ArevaEPRDCPEm Resource

From: WELLS Russell (AREVA) [Russell.Wells@areva.com]
Sent: Friday, July 22, 2011 10:30 AM
To: Tesfaye, Getachew
Cc: KOWALSKI David (AREVA); WILLIFORD Dennis (AREVA); BENNETT Kathy (AREVA); DELANO Karen (AREVA); ROMINE Judy (AREVA); RYAN Tom (AREVA)
Subject: Response to U.S. EPR Design Certification Application RAI No.462, FSAR Ch. 6, Supplement 4
Attachments: RAI 462 Supplement 4 Response US EPR DC.pdf

The attached file, "RAI 462 Supplement 4 Response US EPR DC.pdf" provides technically correct and complete FINAL responses to the remaining nine questions.

Appended to this file are affected pages of the U.S. EPR Final Safety Analysis Report in redline-strikeout format which supports the responses to RAI 462 Questions 06.02.03-8, 06.04-6, 06.04-7, 06.04-8, 06.05.01-2, 06.05.01-3 and 06.05.01-4.

Figure 9.4.1-1—Control Room Air Intake and CREF (Iodine Filtration) Train Subsystem

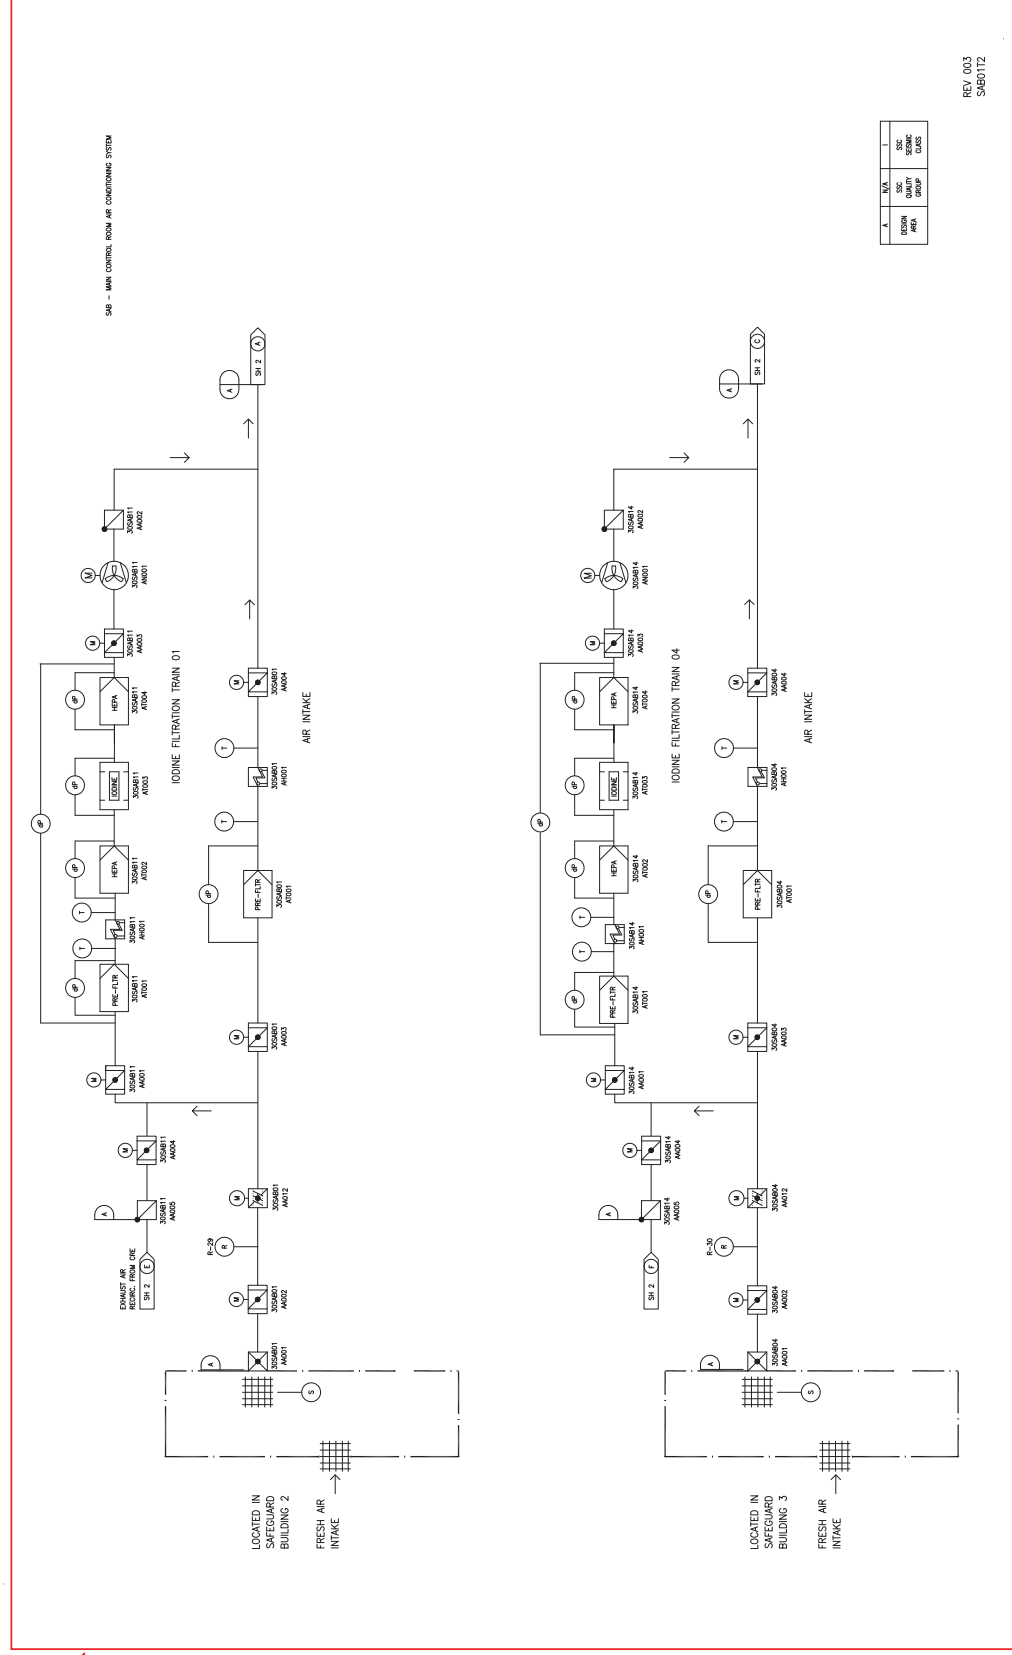
The following U.S. EPR FSAR Tier 2 sections will be revised to reflect the removal of the toxic gas design from the U.S. EPR standard CRACS design:

- Sections 6.4, 6.4.1, 6.4.2, 6.4.3, 6.4.4, 6.4.6, 9.4.1, 9.4.1.1, 9.4.1.2, 9.5.1.2.1 and 14.2.12.8.10.
- Chapter 16, Technical Specifications 3.6.6, 3.6.7, 3.7.10, 3.7.11 and 3.7.12 and Associated Bases.
- Table 1.8-2—U.S. EPR Combined License Information Items.
- Table 3.2.2-1—Classification Summary.
- Table 3.11-1—List of Environmentally Qualified Electrical/I&C Equipment.
- Figure 9.4.1-1—Control Room Air Intake and CREF (Iodine Filtration) Train Subsystem).

06.04-7
